Underwood Pool and Bathhouse

Town of Belmont ADA Transition Plan

October 2020

Figure 1: The diagram above illustrates the 36" min. wide by 48" min. deep clear floor space that is required alongside a transfer shower.

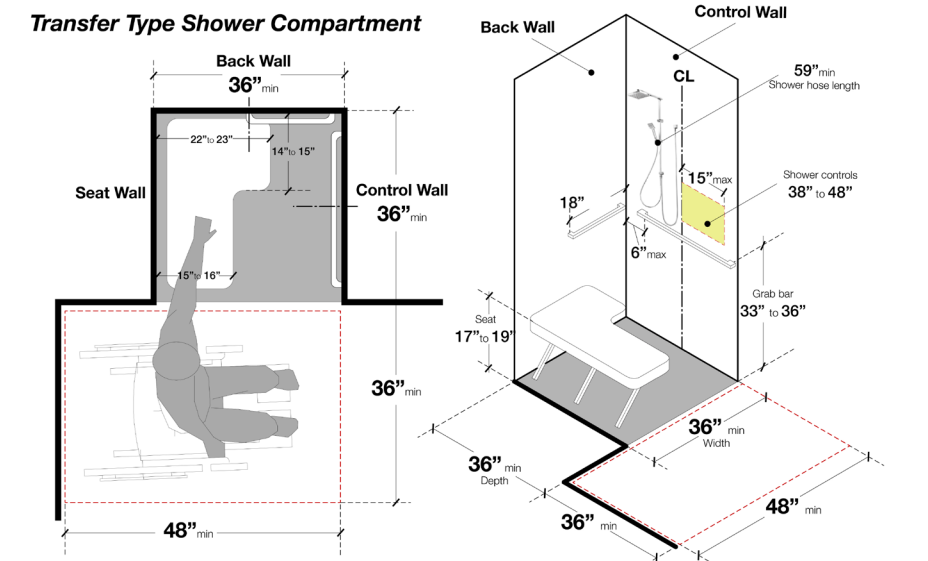
Accessibility issues include lack of a compliant transfer shower at any of the four single-user toilet rooms by the entrance, lack of compliant shower seats in the accessible shower stalls in the men's and women's bathhouses, and lack of a compliant bench in any of the changing rooms.

Note: IHCD recommends bringing one of the four single-user shower-changing rooms by the front entrance into full compliance and updating the designation signage at the other non-compliant single-user shower-changing rooms so that the sign does not include the International Symbol of Accessibility (ISA). IHCD recommends providing directional signage at the single-user shower-changing room by the pool directing users to the nearest accessible shower-changing room. IHCD also recommends updating the shower compartments, toilet compartments and urinals in the men's and women's bathhouses.
